The PSE state diagram does not tell you when type-2 current limits are employed for the scenario where a Type-2 PSE uses 1-Event classification to power-up a Type-2 PD and then uses DLL for mutual identification. A Type-2 PSE that uses 1-Event classification should be able to power-up a Type-2 PD using Type-1 current limits and then switch to Type-2 current limits when mutual identification is completed. Similarly as per the present state diagram, the PSE that skips second finger of 2-Event classification needs to set Type-2 current limits to a Class-4 PD as soon as classification is completed (Done in TYPE2_CLASS_DONE state). This is not the intended behavior as per the text.

Remedy

Section 33.2.4.6 replace **det_pd_type** with:

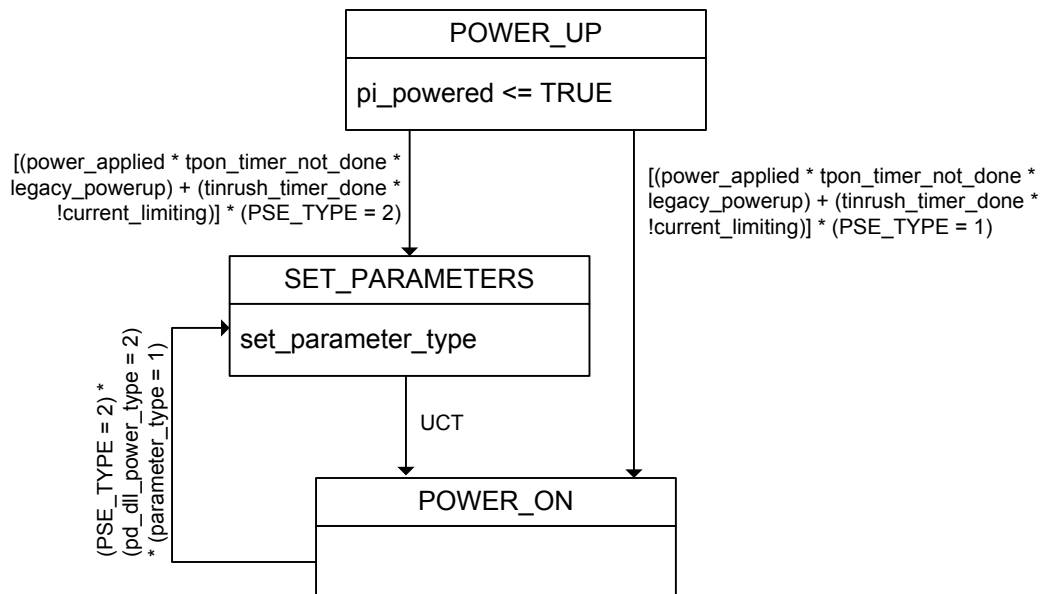
set_parameter_type

This function is used by Type-2 PSE to evaluate the type of PD connected to the link based on physical layer and/or Data Link Layer classification results and sets the parameters defined in Table 33-11 to values corresponding to either Type-1 PSE or Type-2 PSE. The function returns the following variable:

parameter_type

A variable used by Type-2 PSE to pick between Type-1 and Type-2 parameter values defined in Table 33-11

Values: 1: Type-1 PSE Parameter values (default)
 2: Type-2 PSE Parameter values

When a Type-2 PSE powers a Type-2 PD, the PSE may choose to assign a value of 1 for parameter_type if mutual identification is not complete. A Type-2 PSE shall assign a value of 2 for parameter_type if mutual identification is complete.

When a Type-2 PSE powers a Type-1 PD, the PSE shall meet the electrical requirements of a Type-1 PSE but may choose to meet the electrical requirements of a Type-2 PSE for Table 33-11, items 5, 10, 11 and 13.
